W0231-01
Sub 48

Re: Waste Licence Application W 0231-01 Fingal Landfill

Objection By: Kevin Cullen

A review of Geological and Hydrogeological Sections (Vol. 5) of the EIS accompanying the above licence application indicates that there are a number of significant omissions and inaccuracies in the published document.

| Figure 1 | |

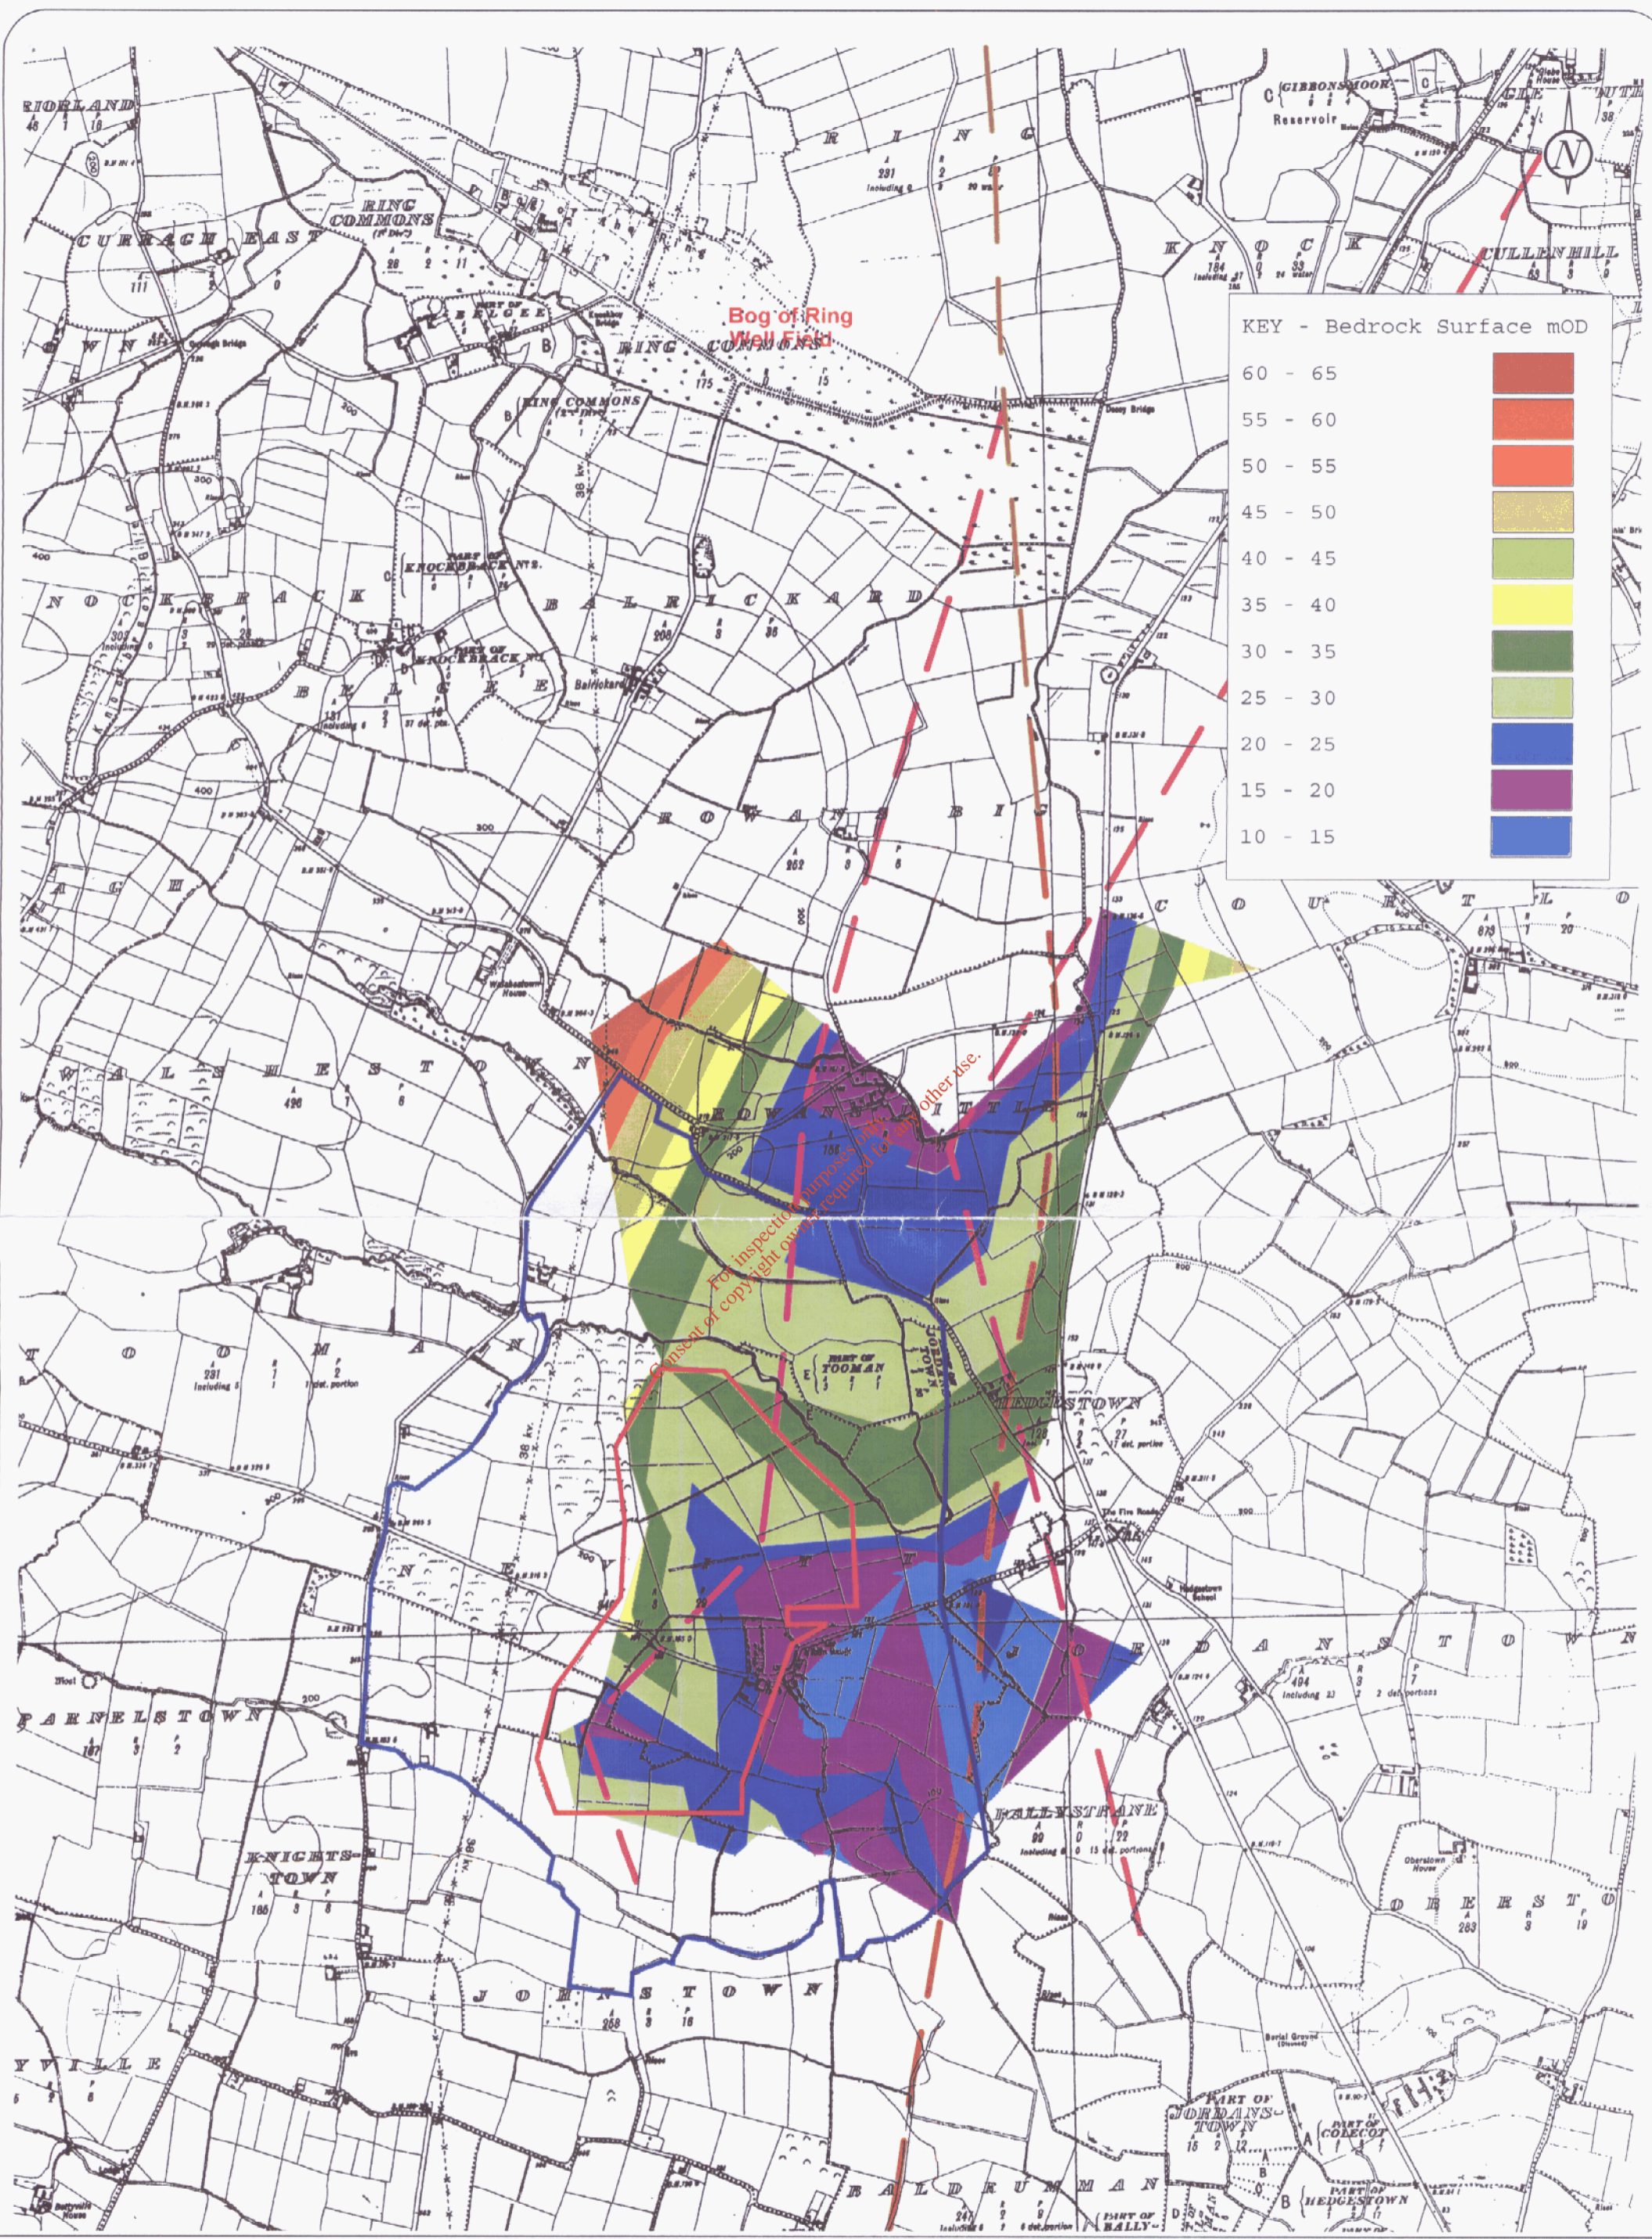
The accompanying Figure 1 shows that a deep north – south trending trough or buried channel is present in the bedrock surface within and beyond the Applicant's study area.

This buried channel feature is also highlighted by the depth to bedrock contours shown in Map 2b of the Final Geophysical Report provided in the supporting documents to Volume 5. In fact the base of the trough is given as close to sea level below the southern part of the landfill footprint.

This bedrock trough or buried channel feature is generally coincident with the postulated major north south fault shown by the GSI Sheet 13 as traversing this part of north county Dublin. The bedrock depression probably reflects a weakening or weathering of the bedrock here as a result of the structural deformation associated with the faulting.

The accompanying Figure 1 also shows how the trace of this postulated structural break is associated with a very broad fault zone which extends beneath the landfill foot print. The exact location of the GSI fault remains uncertain as it might define either the eastern or western edge of the bedrock escarpment or be located in the intervening graben like feature.

For example, at borehole SHR3 in the west of the landfill footprint there is at least a 15m change in the elevation of the bedrock surface between this borehole and the nearby borehole SHR3a which is located approximately only c.60m away.

However, the fault zone presented in the accompanying Figure 1 is more likely to be composed of numerous fault like features and which together account for the structural displacement of the Loughshinny Formation described on the GSI's Sheet 13.

Conclusion: A revised EIS should be published with a map at a scale of 1:10,000 showing the contours of the bedrock surface together with the proposed fault lines and Formation boundaries.

Figure 2

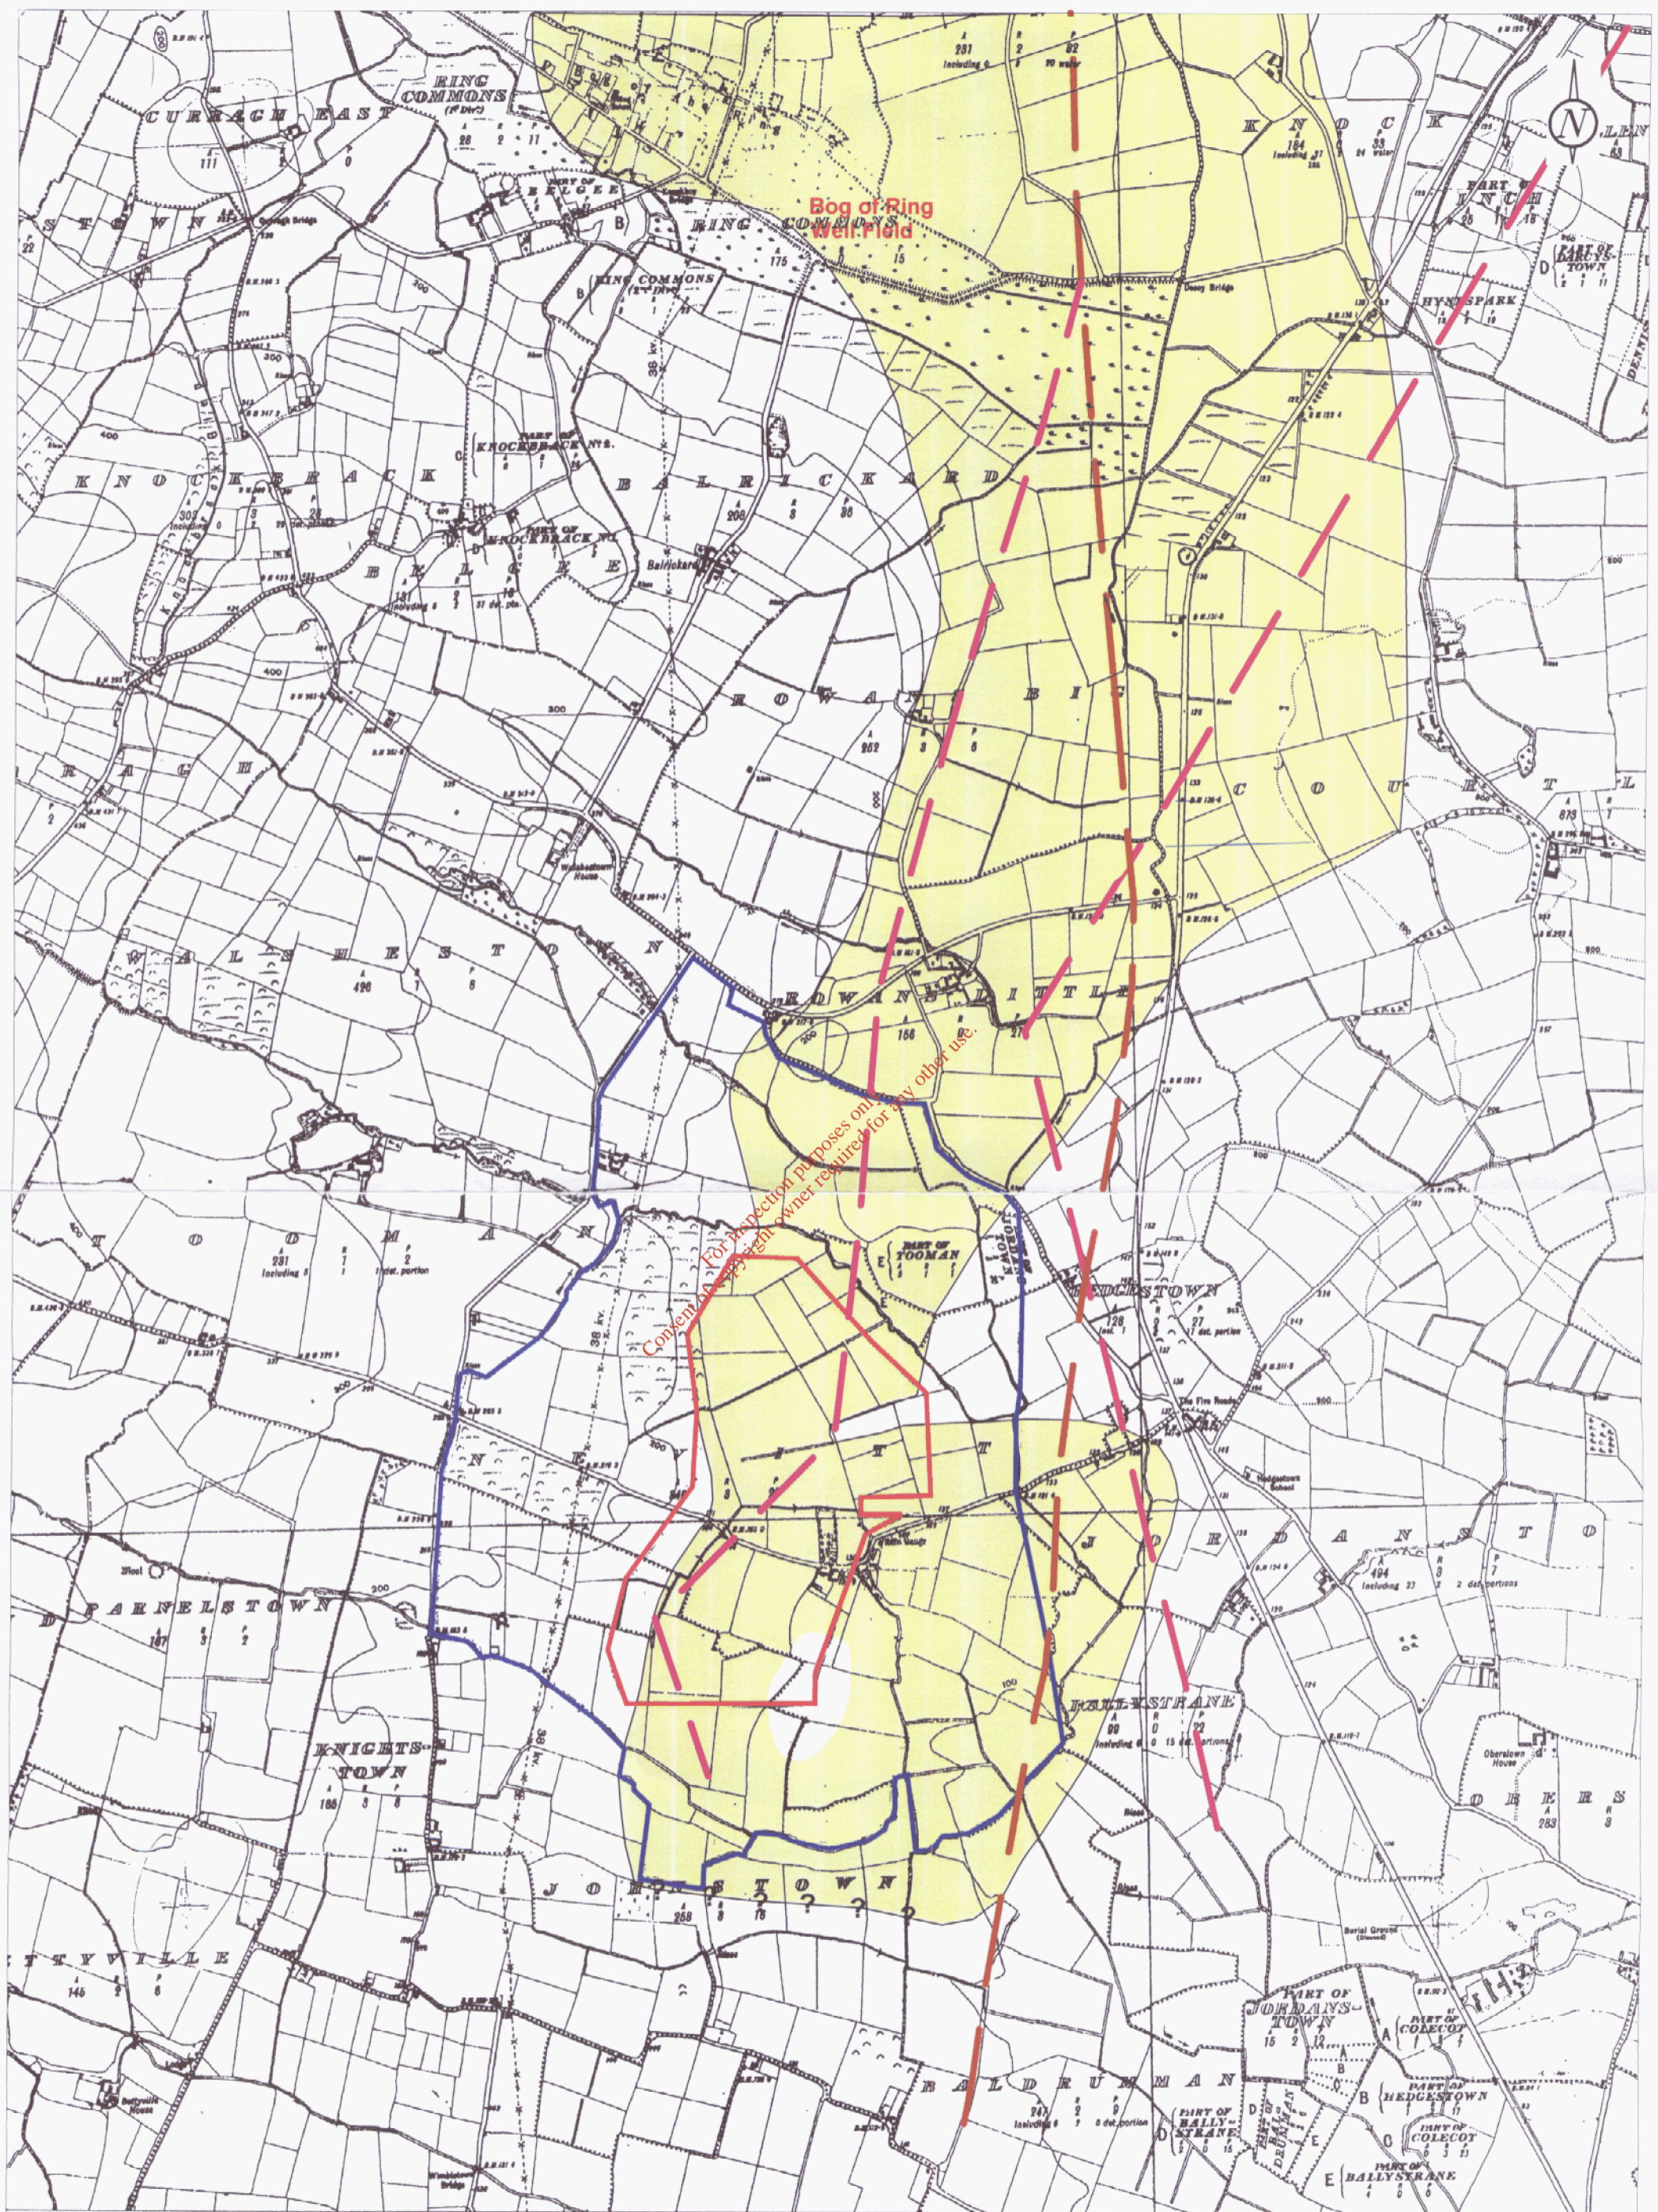
The accompanying Figure 2 indicates the likely extent of this sand and gravel deposit at Nevitt as derived from the borehole logs presented with the EIS. It is obvious from the accompanying Figure 2 that this unit is continuous, very thick in places and open in extent both to the north and south.

Figure 2 shows how the deep bedrock valley outlined on the accompanying Figure 1 is infilled with sands and gravels and which predate the deposition of the overlying glacial till deposits. Figure 2 also indicates that much of the landfill footprint is underlain by the sand & gravel deposit.

The sand and gravel deposits found at Nevitt are a continuation of similar sand and gravels found further north at the Bog of the Ring. The full extent of the sand and gravel deposit remains to be established as the northern and southern ends remain open. The sand and gravel deposits found at the Bog of the Ring well field are understood to be an integral part of the groundwater system that supplies the production wells.

Conclusion: A revised EIS should be published with a map at a scale of 1:10,000 showing the distribution of the extensive sand and gravel deposit found at Nevitt.
